FORRESTFIELD / HIGH WYCOMBE STAGE 1 DEVELOPMENT CONTRIBUTION PLAN

REVIEW OF COST ESTIMATES

CITY OF KALAMUNDA

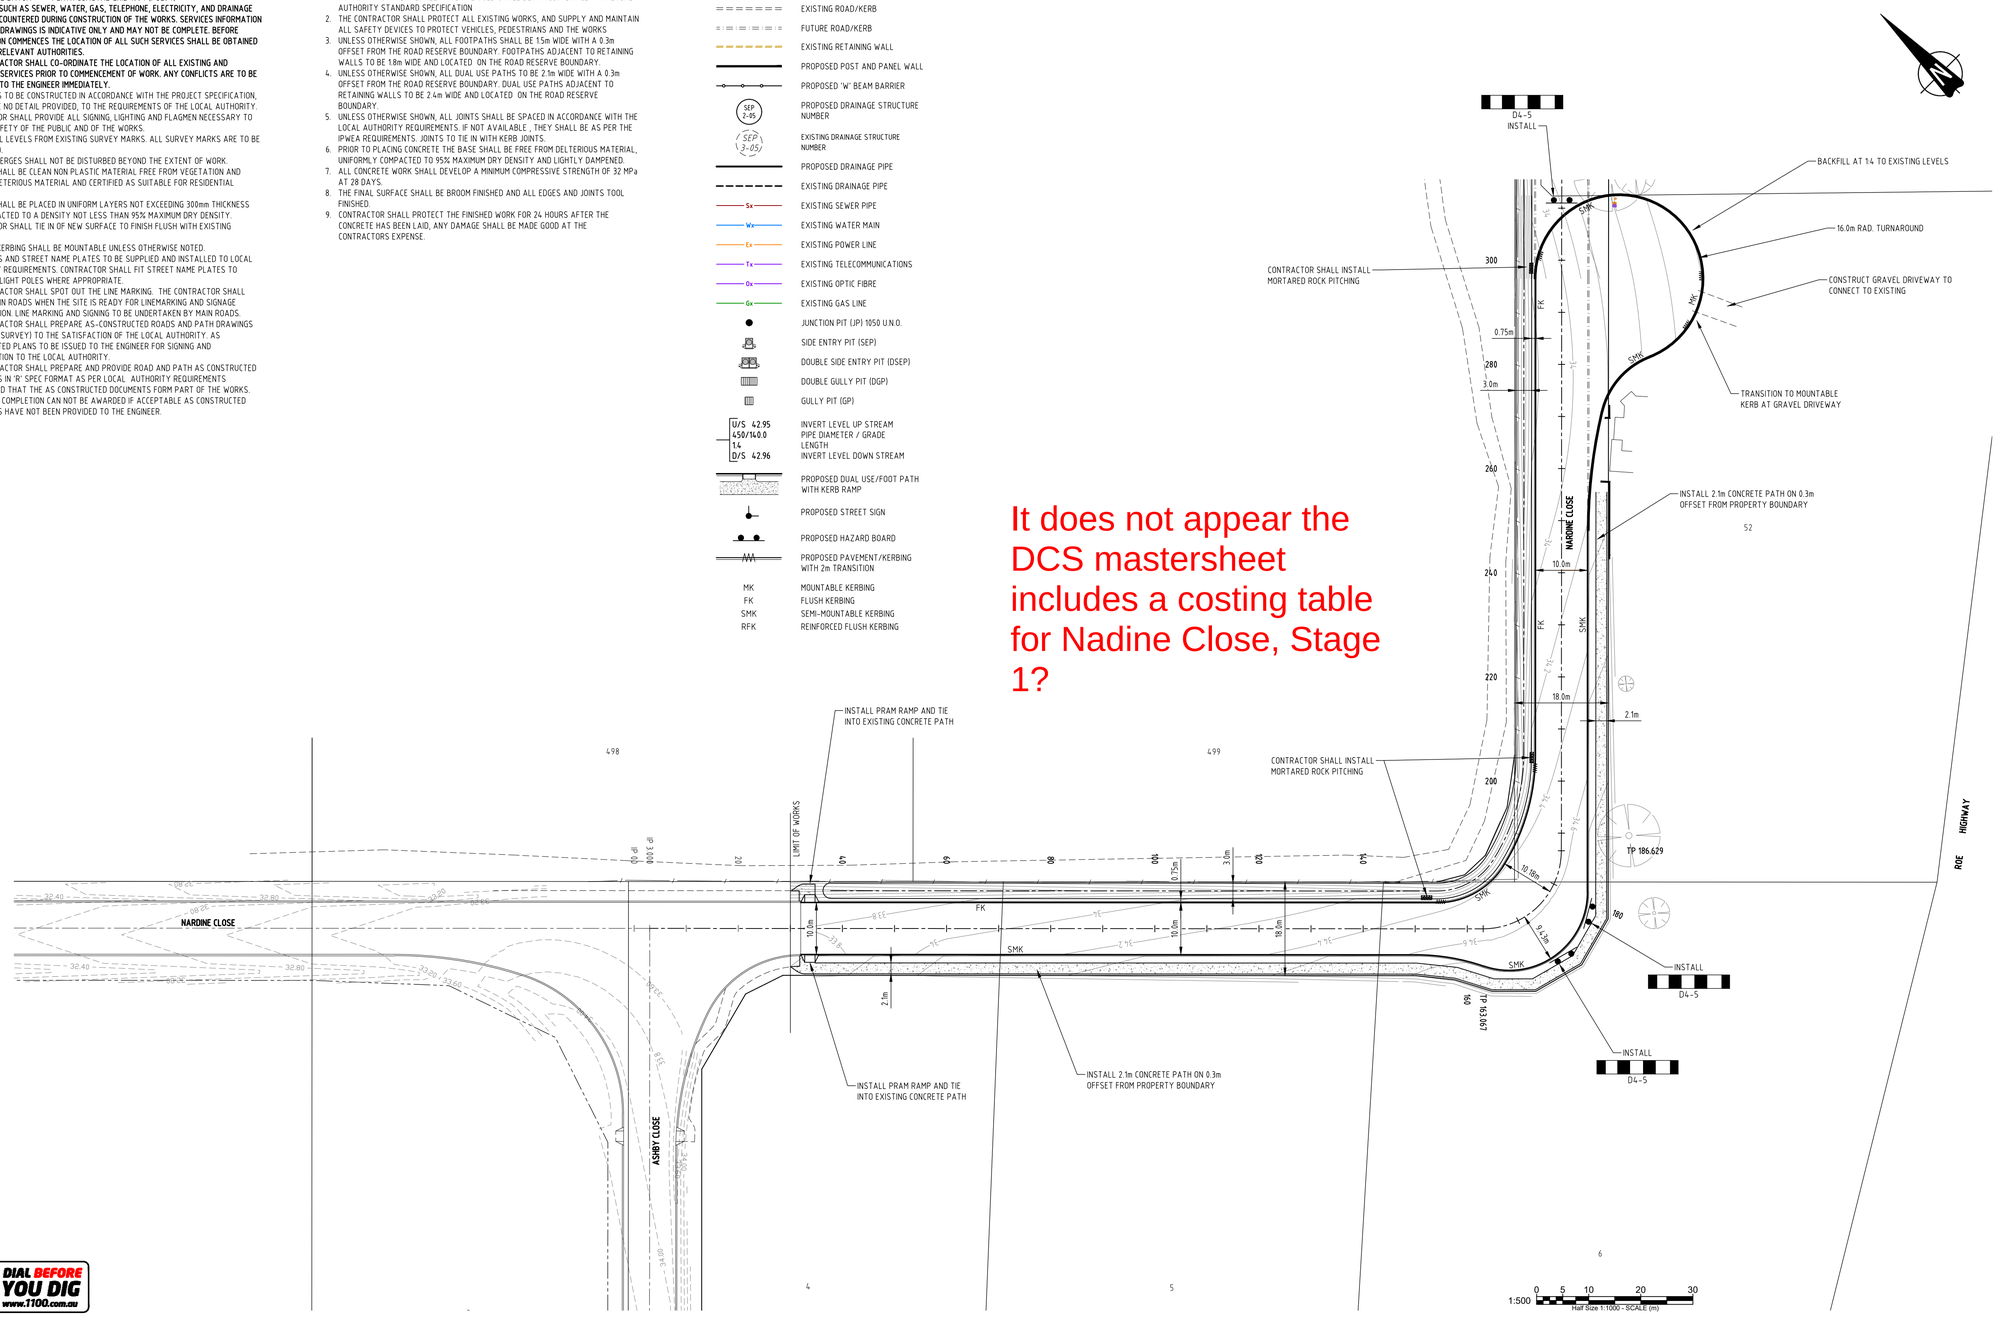
It does not appear the DCS mastersheet includes a costing table for Nadine Close, Stage 1?
